UNITED STATES
NUCLEAR REGULATORY COMMISSION

SUBJECT: FORT CALHOUN STATION - NRC FOLLOWUP INSPECTION - INSPECTION
REPORT 05000285/2010007; PRELIMINARY SUBSTANTIAL FINDING

Report Nos.: 05000285/2010007

.1 IP 92701, "Followup": URI 05000285/2009006-03, "Failure to Update Flood Protection for Safety Related Buildings"

Delta-CDF by Sensitivity Case

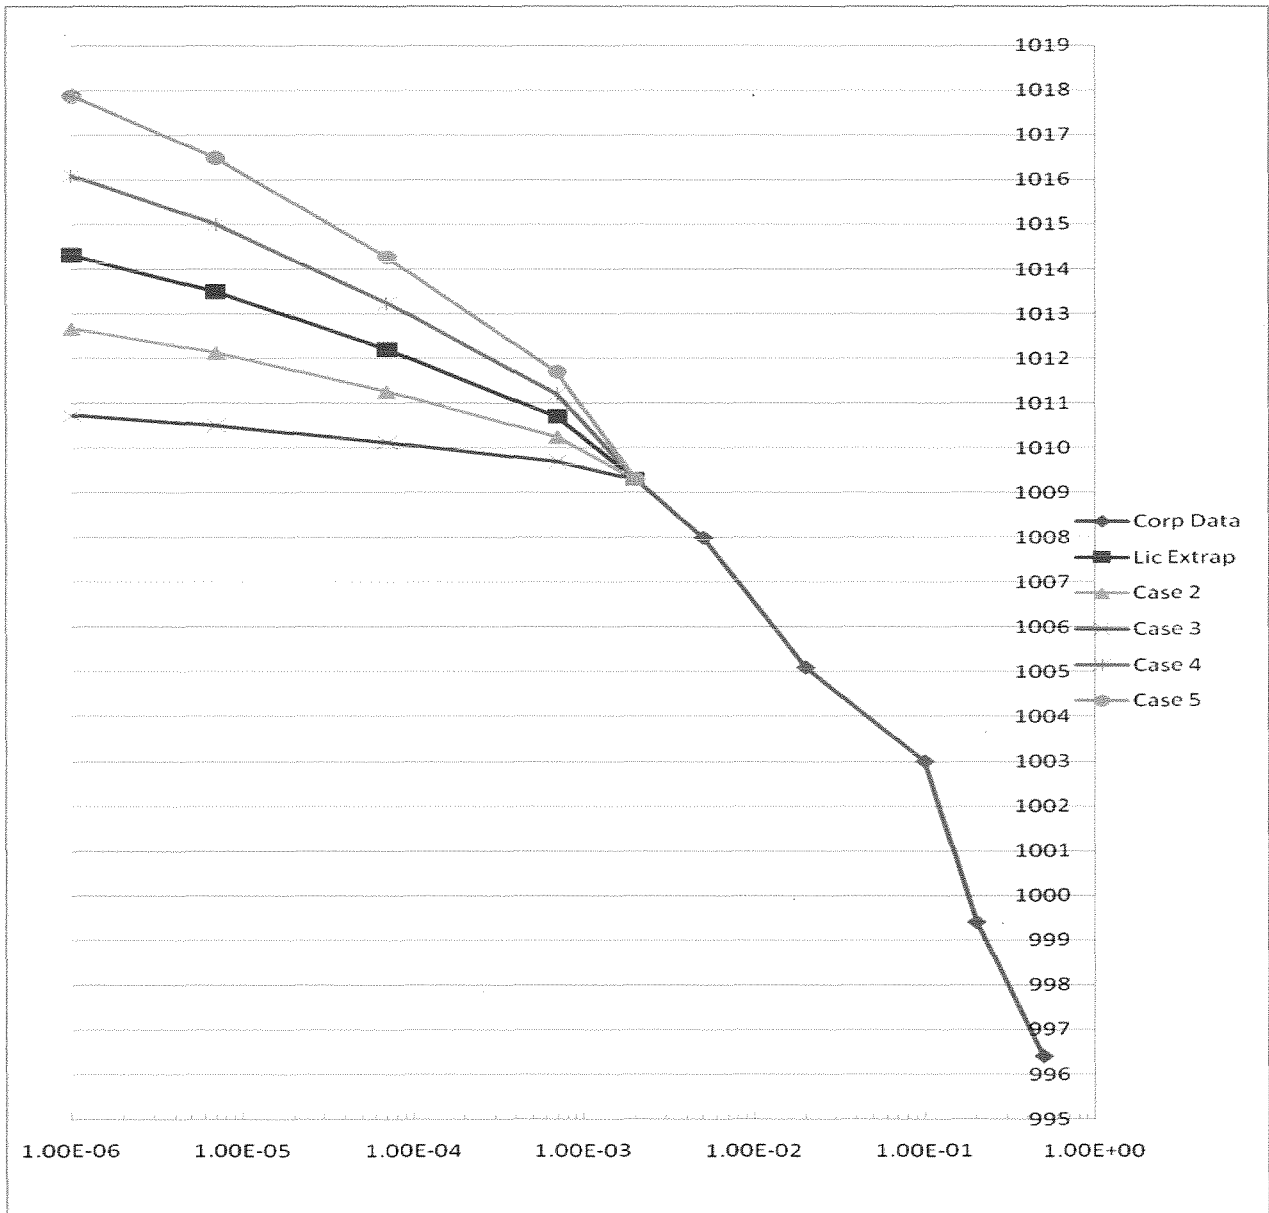
For the sensitivity cases, the analyst targeted the flooding elevation at the 1E-5/year point for comparison. At the 1E-5/year point on the Fort Calhoun flood hazard curve, the flood level was 1013.5 feet MSL. The analyst then constructed alternate curves, two above and two below this base curve. The Curves are shown on the following page. The curves were numbered Case 1 through Case 5. Case 3 was the licensee's estimate and was considered the best available information for this assessment.

Using data from the 5 curves, the analyst generated a delta-CDF for each case. The analyst summarized the results below:

Target Case + Credit for Alternate Essential Feedwater Tank Fill + 50 percent Credit for Placing Panels on Doors

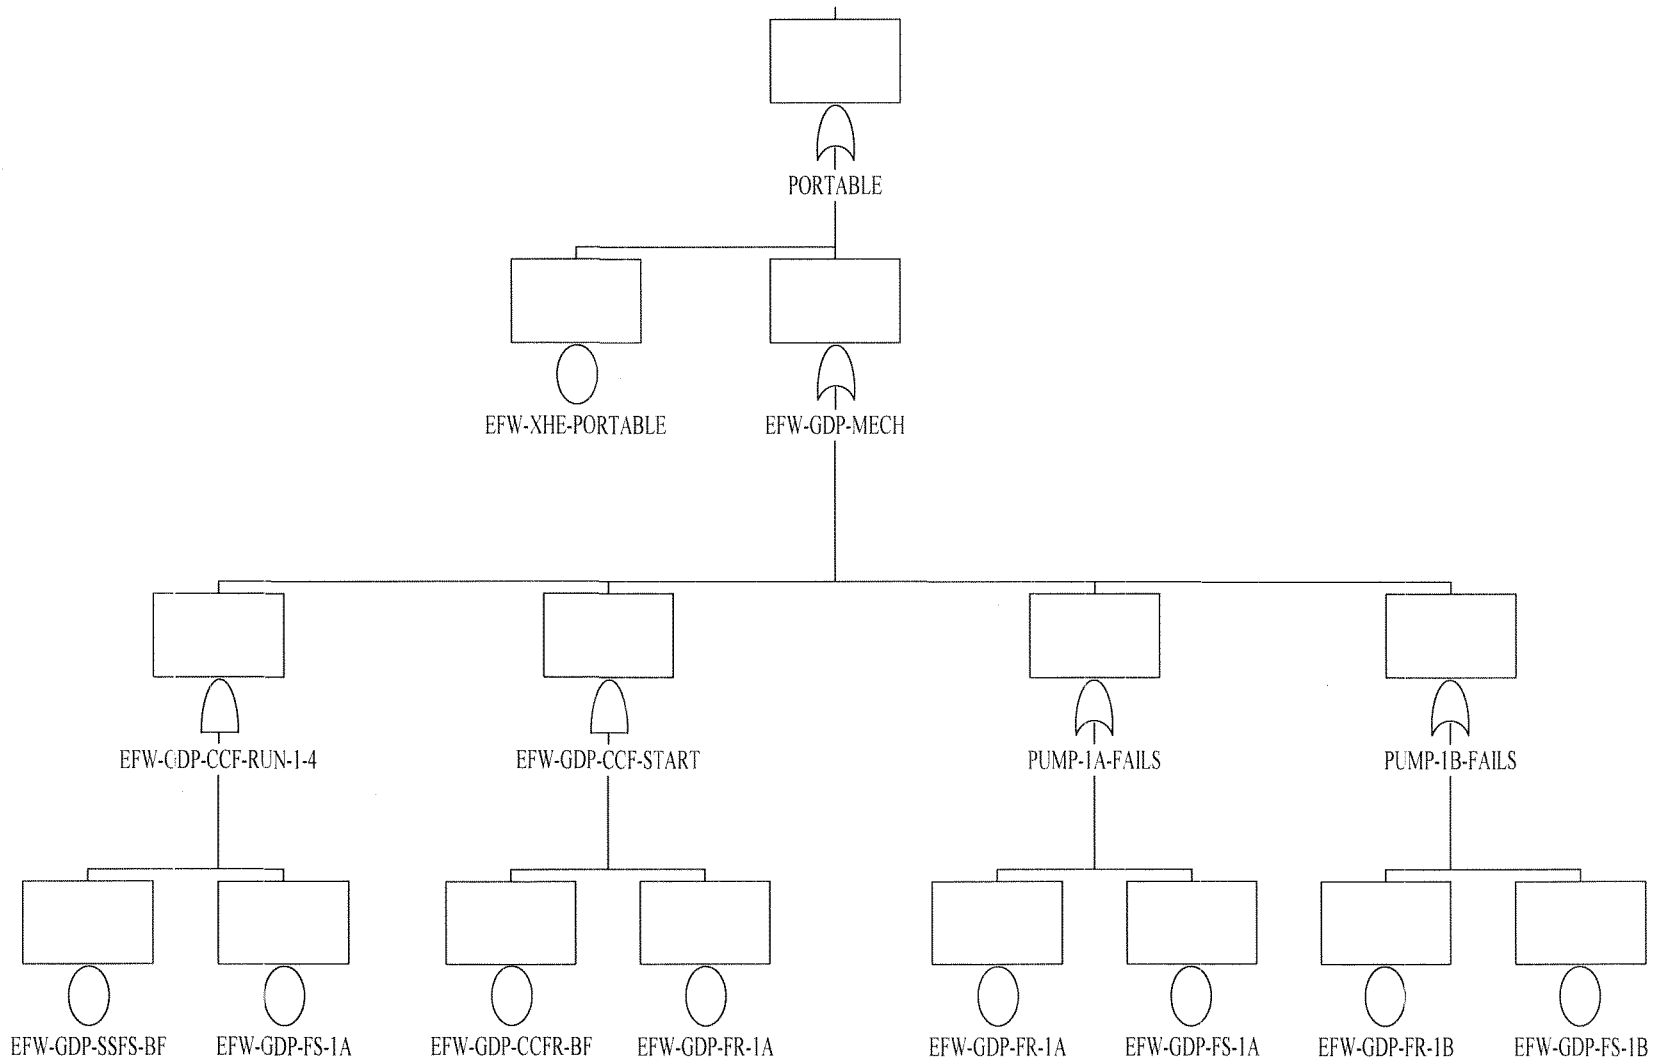
Licensee's extrapolated flood frequency
Credit for alternate feedwater tank filling procedure
No credit for placing panels over doors

$$\text{Delta-CDF} = 1.5\text{E-}5 \text{ -- Yellow}$$

Licensee's extrapolated flood frequency
Credit for alternate feedwater tank filling procedure
50 percent credit for placing panels over doors
